**Panel Closure System Design
Planned Change Request to the
EPA 40 CFR Part 194 Certification of
the Waste Isolation Pilot Plant**

September 26, 2011

Figure 2: Proposed Run of Mine Panel Closure

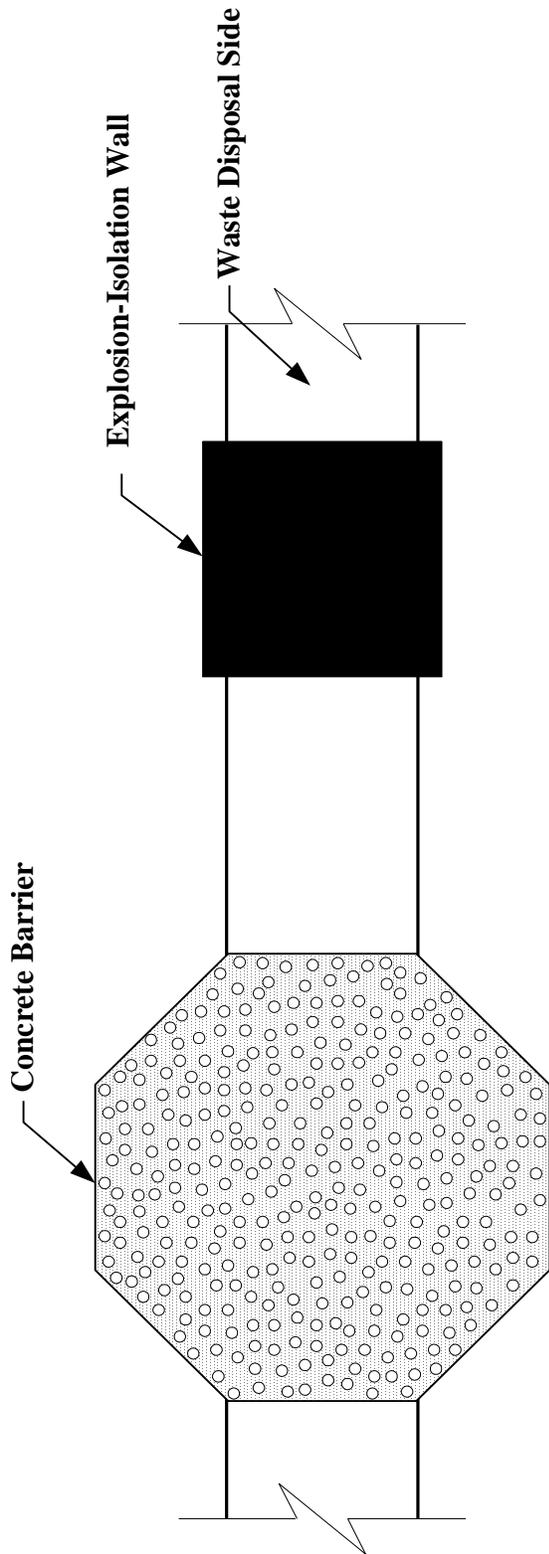
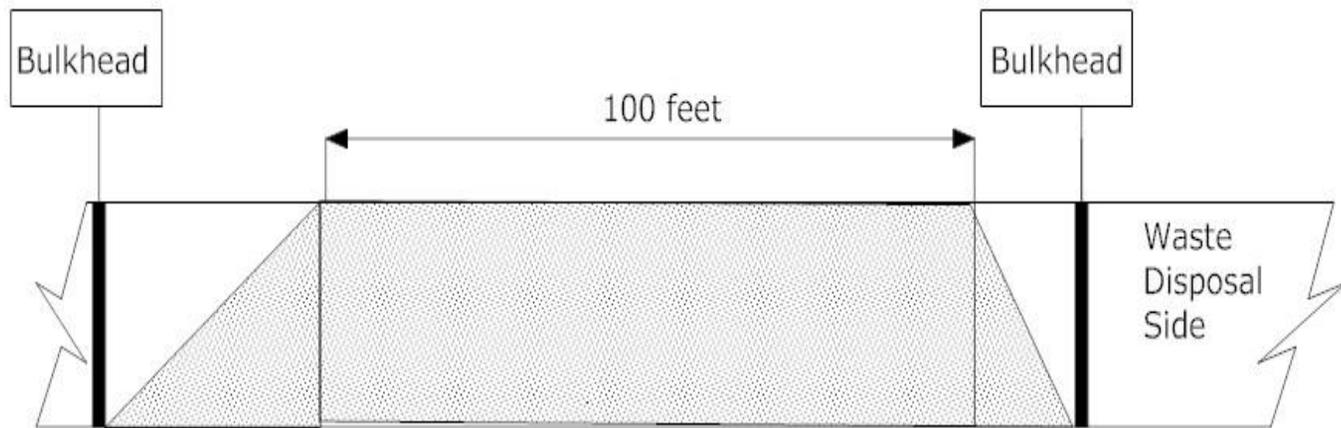
The revised design, known as the Run-of-Mine Panel Closure (ROMPC) comprises 100 ft of run-of-mine (ROM) salt backfill placed between two typical underground bulkheads. The construction methods and materials to be used to implement the design have been proven in previous mining and construction projects. The fabrication, installation, and maintenance of bulkheads are standard mining practices. The ROM salt backfill will be pushed up tight to all salt

surfaces of the drifts, including the back or roof. Over time creep closure of the drifts will cause the salt backfill to consolidate to a condition approaching intact salt with a low permeability.

The proposed design change presented here affects only the design of the panel closure system, as detailed in Condition 1 of the Final Certification (EPA, 1998a) and in the Permit (NMED, 2010) issued by the NMED. Condition 1 currently prescribes the installation of Option D with SMC. This design consists of emplacing a 12-foot concrete block explosion wall, removing most of the DRZ in the area of the closure, and emplacing a large concrete monolith (26 feet long). The concrete monolith would be keyed into the surrounding salt and the upper concrete/salt interface would be grouted. Figure 1 is a schematic representation of Option D provided in the CCA, Attachment PCS (DOE, 1996).

Based on these analyses and results, the DOE is requesting that the EPA remove Condition 1 as presented in the Final Rule (EPA, 1998a), and accept the revised design for panel closures as described herein.
